AGENDA - LPP

Meeting:	Georges River Local Planning Panel (LPP)
Date:	Thursday, 20 June 2019
Time:	4.00pm
Venue:	Council Chambers, Civic Centre, Hurstville
Panel Members:	Paul Vergotis (Chairperson) John Brockhoff (Expert Panel Member) Michael Leavey (Expert Panel Member) George Vardas (Community Representative)
Council Staff:	Meryl Bishop (Director Environment and Planning) Nicole Askew (Coordinator Development Assessment) Cathy Mercer (PA to Manager Development and Building) Sue Matthew (Team Leader DA Admin) Monica Wernej (Admin Assistant)

LPP Report No	LPP015-19	Development Application No	DA2018/0462
Site Address & Ward Locality	87 Woronora Parade Oatley Mortdale Ward		
Proposed Development	Demolition works and construction of detached dual occupancy with swimming pool and cabana on each lot		
Owners	365 Project Management Pty Ltd		
Applicant	J Chen		
Planner/Architect	ARC Homes Australia		
Date Of Lodgement	6/11/2018		
Submissions	28		
Cost of Works	\$740,000.00		
Local Planning Panel Criteria	The development has received more than 10 unique submissions by way of objection.		
List of all relevant s.4.15 matters (formerly s79C(1)(a))	State Environmental Planning Policy No 55 –

Figure 25: Stairs relocated to the east

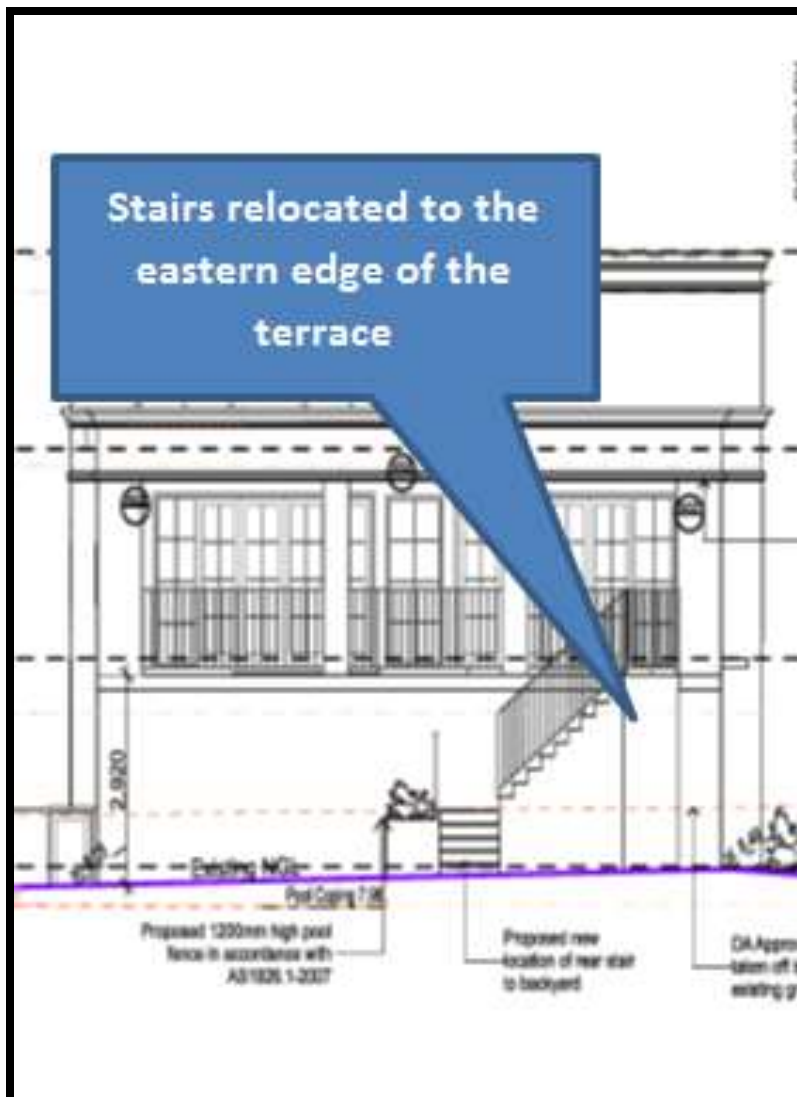
24. External Stairs to the Rear Terrace – Contrary to the approval, a flight of stairs has been constructed along the northern edge of the rear terrace to provide access from the pool area to the rear terrace. These stairs are proposed to be demolished. A new set of stairs will be constructed to the eastern edge of the terrace whereby the setback between the northern edge of the terrace and the northern boundary is increased and screening installed.

98. A flight of stairs has been constructed along the northern edge of the terrace. The stairs wraps around the northern and western face of the terrace and overlooks the private open space of adjoining properties. The subject proposal seeks to relocate stairs to be situated entirely along the eastern elevation as shown below in Figure 23.
